Subject: RAI (TAC NO. MD3410)

Docket No. 50-184

Attachment 1
RAI (ACRS Meeting)

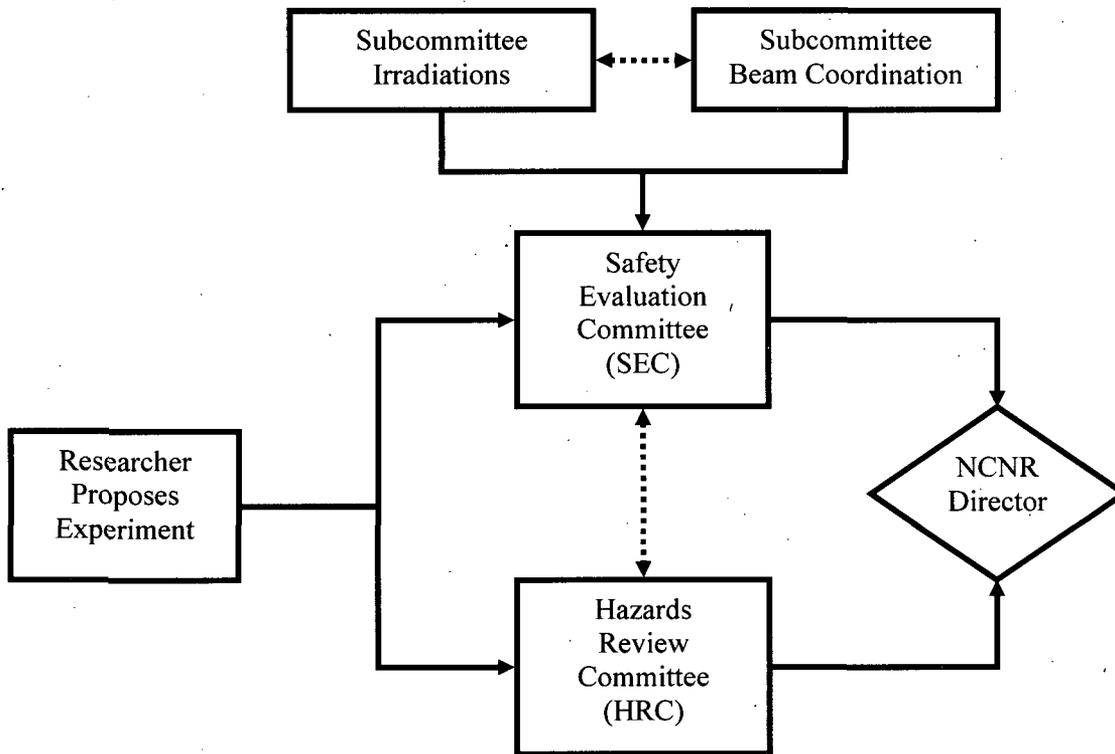
3. The most recent revision of the proposed Technical Specifications(TSs) submitted September 16, 2008, contains some surveillance requirements that are less conservative than those specified in the current TSs and/or those recommended by the guidance contained in American National Standard ANSI/ANS -15.1-2007. These surveillance requirements include that starting function of the emergency sump pump, start testing of the diesel generators, and voltage and specific gravity testing of the station battery. For each deviation from the standard, please provide a discussion that explains why the recommended surveillance requirement contained in ANSI/ANS - 15.1-2007 is inappropriate or overly –conservative for the NBSR. For each decrease in conservatism in the surveillance requirements in the proposed TSs for the surveillance requirements in the current TSs provide a discussion that explains how the decrease in conservatism maintains the current level of safety. Alternately, revise the proposed TSs to be in conformance with the standard and/or the current TSs.

An annual frequency for emergency coolant supply testing is stipulated by section 4.3(2) of ANSI/ANS-15.1-2007. Section 4.3(1) stipulates a quarterly frequency for start testing of an emergency sump pump. The NBSR has three independent emergency coolant supplies: a 3000 gallon tank; the sump pump; and a potable water header. Given the number of redundant sources, ALARA considerations, demonstrated reliability and the manufacturer's recommendation of a 1500 hour maintenance interval, an annual test of the motor/pump is the most appropriate surveillance frequency. A quarterly frequency for diesel testing is permitted by section 4.6.1(1) of ANSI/ANS-15.1-2007. A semi-annual frequency for voltage and specific gravity testing is permitted by section 4.6.2(1) of ANSI/ANS-15.1-2007. An annual frequency is justified because: the battery manufacturer permits maintenance frequencies other than those recommended based on the user's policies and if checked with adequate records; ; data collected over 40 years demonstrates that individual battery cells fail in capacity and in numbers at a rate which will ensure that the entire battery is operable for at least a five year period and because the entire battery is twice the size than that needed to be considered operable; the NBSR has three emergency power supplies; and chemical and electrical hazards associated with the maintenance can be reduced with a reduced maintenance frequency.

Figure 1. RELAP simulation of closing of DWV-19 at full power.

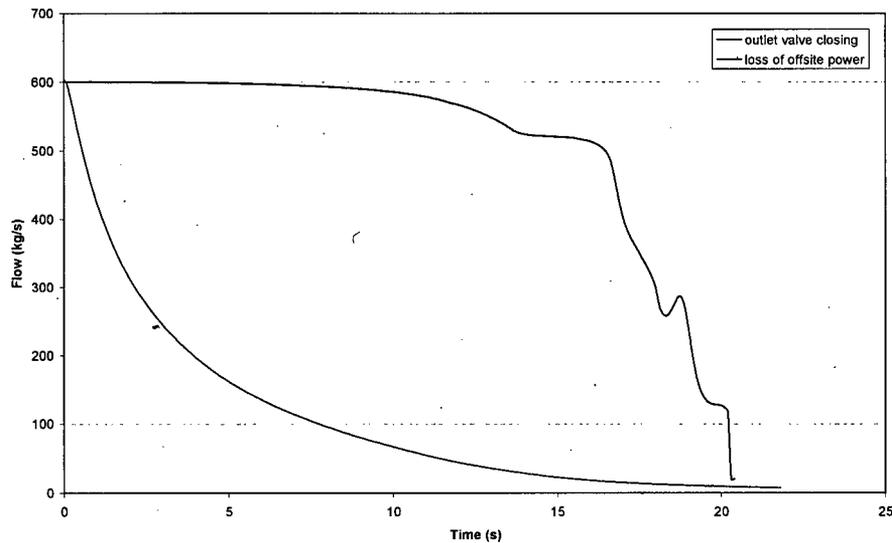
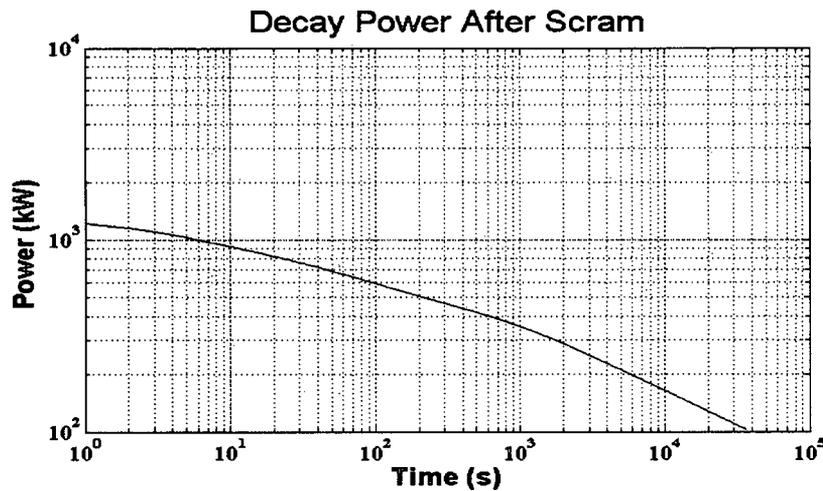
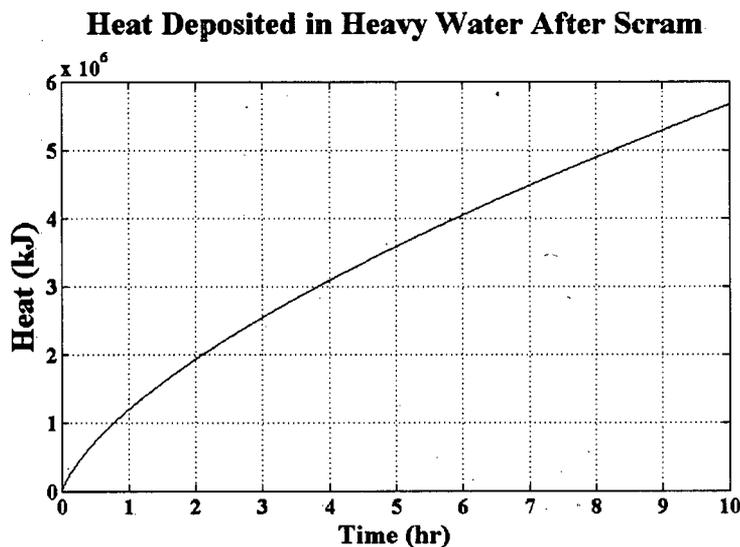
5. Please provide a discussion and analysis of the adequacy of natural circulation cooling in the event that DWV-19 is isolated during extended full-power operation. Include discussion of heat sinks, flow paths, peak vessel temperature, and ability of the pressure relief valve to perform its intended function. Also please discuss any actions or preventative measures needed to mitigate the consequences of such a occurrence or prevent it altogether.

Valve DWV-19 is a motorized 18 in. butterfly valve mounted in the outlet line from the NBSR, with a measured stroke time, fully open to fully closed, of 21 seconds. Although DWV-19 is used only during maintenance, it is conceivable that it could receive a spurious signal while operating, causing a loss-of-flow accident of a type different from those already analyzed. The characteristics of this valve have been used to generate a transient analysis of the system using RELAP, with the results shown below. The starting power and flow are chosen (as for all accident analyses) as being at the alarm setpoints for power, primary inlet power and flow. The reactor is assumed to have been operating at full power for a full cycle when the spurious signal to close DWV-19 is received. The valve is assumed to go from fully open to fully closed in the measured stroke time of 21 seconds.

As can be seen from Figure 1, Table 1 and Appendix A there will be no departure from nucleate boiling during the forced flow reduction, given the CHFR and OFI ratio found for this accident. Further, the model used is the same as was used for the SAR, which has been shown to be very conservative, since it ignores thermal conductivity of the fuel and clad, non-local deposition of energy at the hot spot, and non-uniform burnup. The factors mentioned decrease the peak heat flux by a factor of 1.6, giving a very large margin to fuel damage. Previous calculations reported in the SAR show that natural circulation is adequate to maintain the fuel clad temperature well below the Safety Limit following a scram. However, it is

necessary to address the heating of the heavy water moderator during removal of the decay heat from the fuel after primary circulation is stopped. The decay power from the core has been estimated using the methods described in ANS-5.1, and assuming that DWV-19 closes at the worst possible point of the cycle – the end of cycle, where the decay heat will be largest, with the results shown below.

Figure 3. Total heat deposited in heavy water, assuming no heat sinking to the vessel or biological shield.

The results given in Figure 3 can be used to estimate the temperature rise of the moderator with DWV-19 closed, again assuming no heat transfer to the reactor vessel or biological shield. The total volume of heavy water in the vessel can be calculated from the data given in the SAR. In particular, the diameter of the vessel is 2 m, and the height of the heavy water is at least 3.81 m above the lower grid plate. This gives a volume of heavy water of 12 m³, to which must be added the volume below the lower grid plate. This volume corresponds closely to the elliptical shell that forms the bottom of the vessel, which has a volume of 1.57 m³, for a total volume of 13.5 m³. The density of heavy water at saturation temperature and 1 bar pressure is 1062 kg/ m³ and it is conservative to use this value for our estimates of water heating. The specific heat of heavy water is approximately 4.18 kJ/kg/K at representative temperatures and pressures, so that for the total volume of heavy water, a temperature rise of 1K will require a heat addition of:

Thus, using the results shown in Figure 3, after 2 hours in which less than 2×10^6 kJ will added to the water, the temperature will have risen by only 33 K, thus remaining well below the saturation temperature, and this provides more than ample time to open DWV-19 manually, and restore normal circulation.

Thus, the spurious closing of DWV-19 while operating the reactor at 20 MW will not result in any fuel damage.

**K-infinity (x,y) vs. Separation Distance for NBSR
Fuel Elements (360-g U-235) in Light Water**

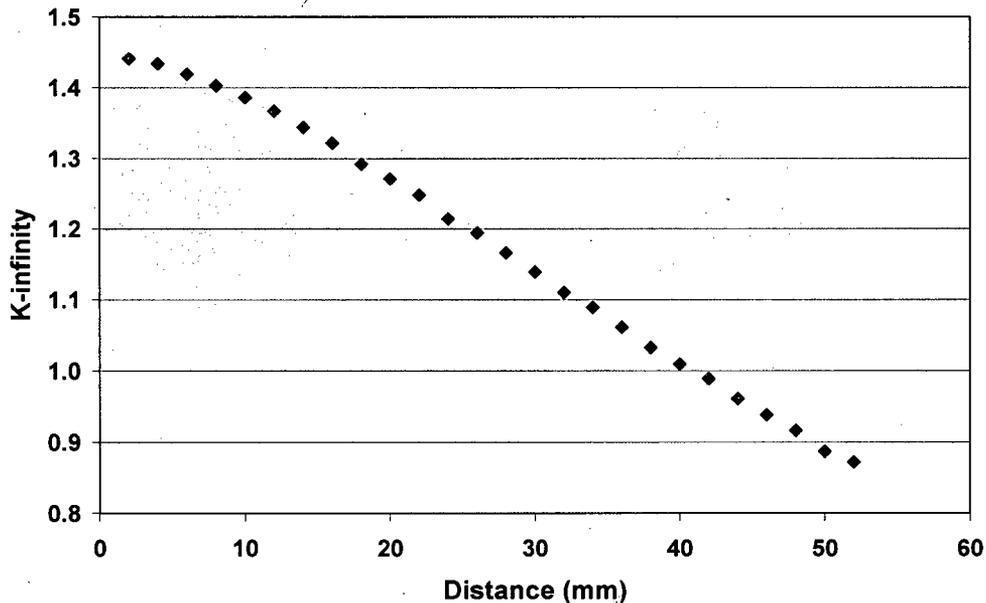
8. Proposed TS 3.9.1, “Fuel Storage”, specified that “all fuel elements shall be stored and handled in geometry such that the calculated k_{eff} shall not exceed 0.90 under optimum conditions of water moderation and reflection”. Please provide a summary and discussion of this calculation for storage in the spent fuel storage pool. Note that your response should not contain any sensitive or security-related information.

A series of MCNP criticality calculations was performed to estimate k_{eff} for each of the four types of fuel storage racks in use in the NBSR Spent Fuel

Pool. In each rack, it is possible to model a “unit cell” of the rack, and, by the use of parallel reflecting boundaries, determine k_{∞} for an infinite line of unit cells. All of the allowed configurations are far subcritical, 0.5 to 0.62, as can be seen in the table below. The calculations were very conservative in that the elements were loaded with 360 grams of ^{235}U rather than the nominal value of 350 g, and there was no allowance for burnup, nor were there any fission products present. Details of the calculations are in the report “Criticality Safety Evaluation of the Fuel Storage Racks in the NBSR Spent Fuel Pool” by R. E. Williams, dated March 15, 2009.

Criticality safety is assured in the pool by the separation distance between the FEs when they are secured in position in each type of rack, and by the fact that only one FE is being moved at any time. An infinite plane of FEs was also modeled to show the dependence of k_{∞} on the thickness of light water between the elements. In the figure below, it can be seen that an infinite array is safely subcritical if there is just a 5-cm layer (2 inches) of H_2O in each direction ($k_{\infty} = 0.88$) between the FEs. The racks are a minimum of 18 inches apart. The maximum k_{eff} for 6 FEs in H_2O is 0.78, when they are packed into a corner of the pool (procedures allow 6 FEs to be placed temporarily outside of any rack). Finally, the racks are securely mounted on the walls or bolted to the floor so they cannot be moved.

There is no possibility of an inadvertent criticality in the NBSR Fuel Storage Pool if the elements and fuel pieces are secured properly in the four types of storage racks currently in use, and the procedures for moving fuel are strictly followed.

Figure 1. Relationship of Return Period to Annual Probability Distribution of Extreme Wind (1 minute sustained at 10m, in knots).

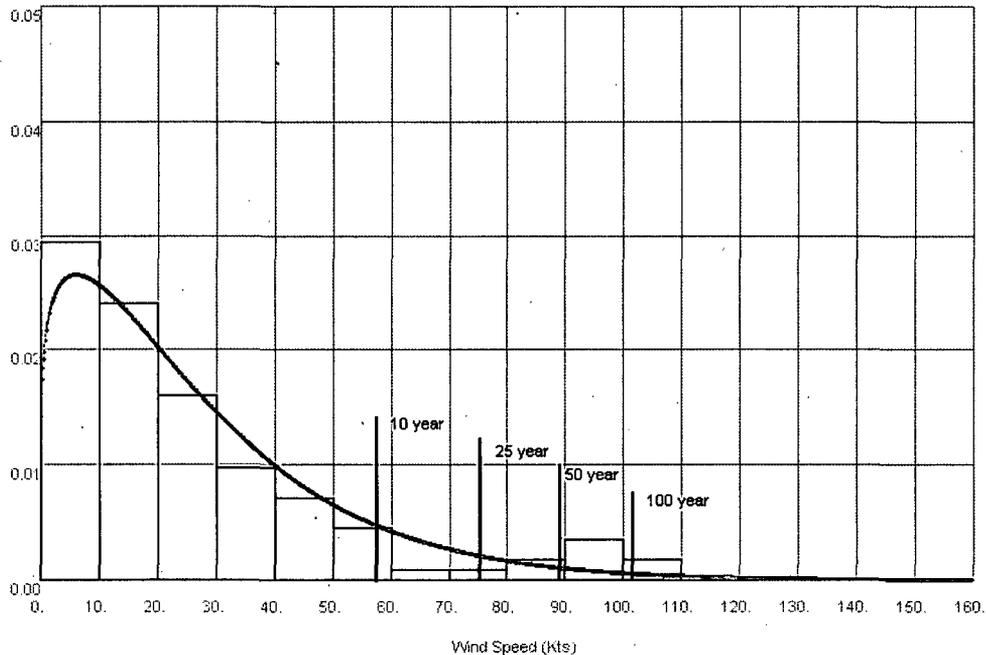
10. Please provide a discussion of the derivation of the 50-year and 100 year numerical scaling factors for wind speeds. If Caribbean hurricane wind data was used to estimate the 100-year maximum wind gust speed at the NBSR site, please provide a discussion of the relevance of that data to winds at the NBSR site. Otherwise, please provide a discussion of the wind data used to estimate the 100-year maximum wind just speed for the NBSR site.

The referenced ratios were obtained by dividing the 100-year Mean Recurrence Interval (MRI) wind speeds by the 50-year MRI wind speeds from typical probability curves (or charted data from same) in each of the referenced documents. The relevant charts (Figure 1 and Table 1) from the second reference (*Return Period of Hurricane Perils...*, original document footnote #7) are attached here for reference. Figure 1 shows a standard reverse Weibull distribution curve that has been fit to a set of data for the Kingston, Jamaica Metropolitan Area (KMA). Table 1 provides the same information in a different format, with the first column corresponding directly to curve in Figure 1, (MLE = Maximum Likelihood Estimate). From Table 1 we take the 100-year and 50-year numbers and divide to derive the MRI multiplier: $102/89=1.146$.

For this to be functionally applicable two things must hold true. First, the Weibull distribution must be reliable. This has been borne out by research; both Simiu and Heckert (1996) and Simiu and Whalen (1998) demonstrate that regions characterized by both extratropical storms and hurricanes are

best represented by reverse Weibull distributions. Second, the shape a variety of Weibull curves must be sufficiently regular for the ratio to be nearly constant. An examination of a limited number of curves reveals some variation with higher ratios found in regions with more frequent and higher-intensity storm, as characterized by the KMA data discussed above.

For the United States a simple conversion is offered by ASCE-7-2005 in Table C6-7 (attached for reference). This table gives the ratio as 1.07 for all regions except Alaska, which is given as 1.06. From this you can see that the MRI multiplier derived in the original document is somewhat conservative, as would be predicted by the use of Caribbean hurricane data.

FIG. 1
Minimum Allowable Resultant Wind Pressures

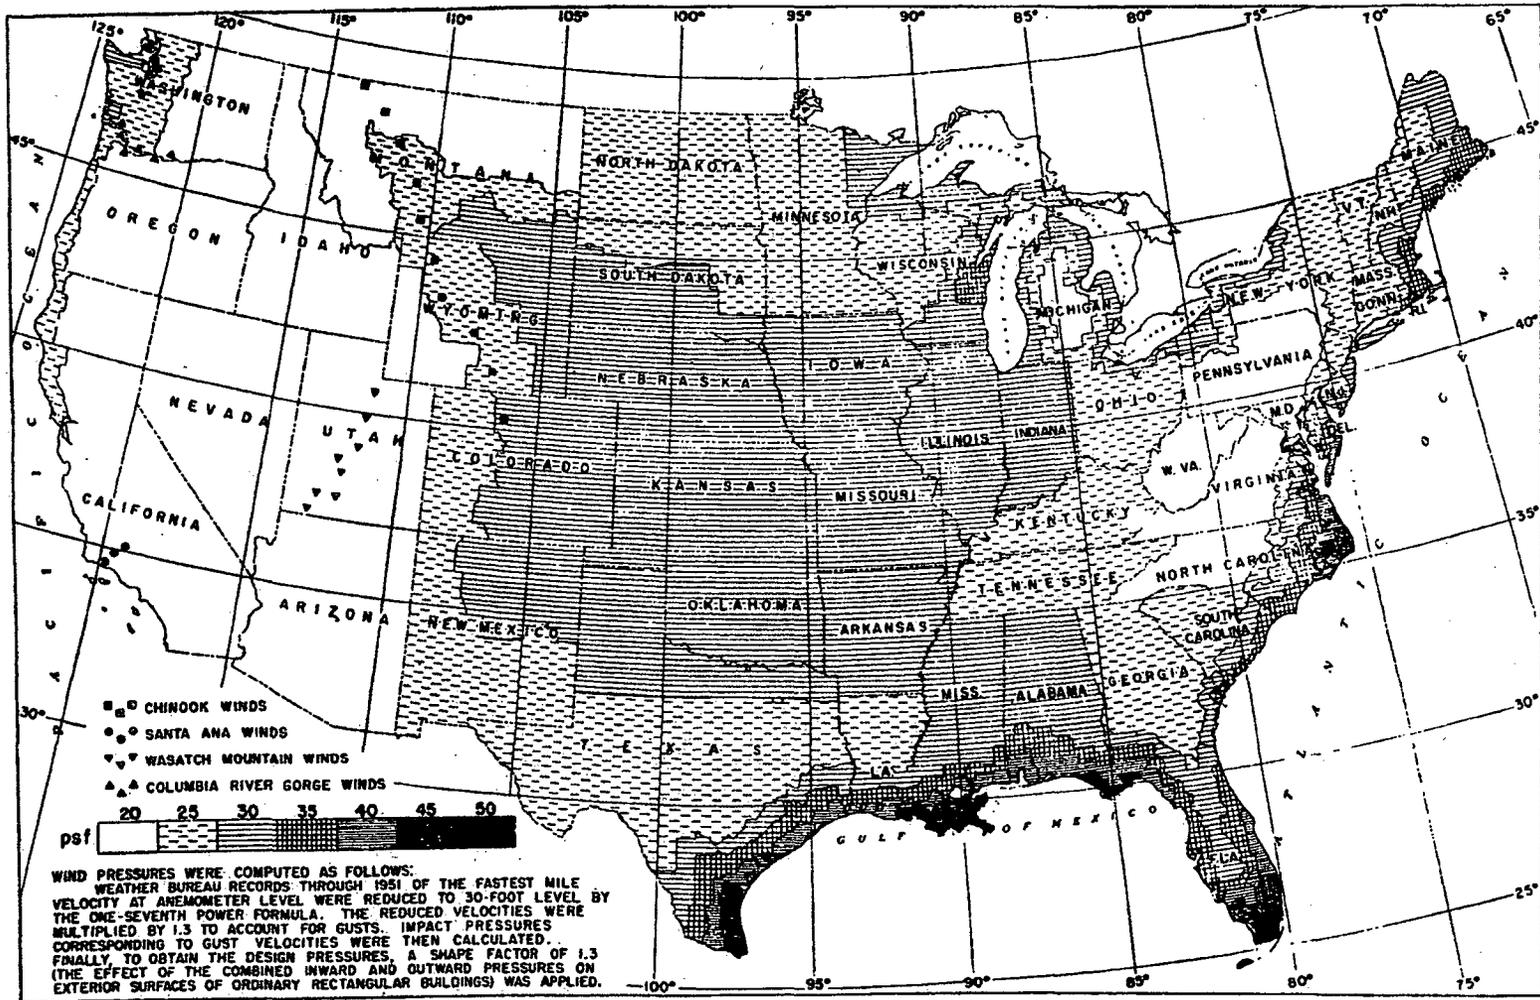
9. Please clarify whether the confinement building design is based on loading from 100-mph sustained winds or a 100-mph wind gust.

At the time of original construction (planning 1958; construction start 1963; construction complete 1968) the governing code in Gaithersburg, Montgomery County, Maryland was BOCA (Building officials Code Administrators), 1955 edition. The wind load provisions of this version of BOCA were based on ANSI A58.1-1955, Minimum Design Loads in Buildings and Other Structures (Note: the name shared with the modern ASCE 7 is no coincidence; ANSI A58.1 is the predecessor document). In ANSI A58.1-1955 wind speeds were not given on any basis; the design process was based solely on "Minimum Allowable Resultant Wind Pressures" as shown graphically in Figure 1 (copy attached) and provided for selected locations in Table A7.

However, as noted in the original document, early codes typically used fastest-mile wind speeds. This is because the typical equipment of the time could not record short duration (gust) speeds. Thus, we presume that the

background data used to develop the method in ANSI A58.1-1955 was recorded on a fastest-mile basis but no documentation could be found to support this.

“Sustained Wind” is defined today by NOAA as “The wind speed obtained in the U.S. by averaging observed values over a period of at least 1 minute.” Because the fastest-mile method is effectively an averaging function over variable time – varying according to the wind speed (see original text for explanation) – it would be categorized as “sustained” for winds speeds less than 60 mph. Higher wind speeds, such as the extreme event speeds under consideration here, would not be categorized as “sustained” (for example, the 100mph speed referenced in the question would be measured by the fastest-mile method in 36 seconds).
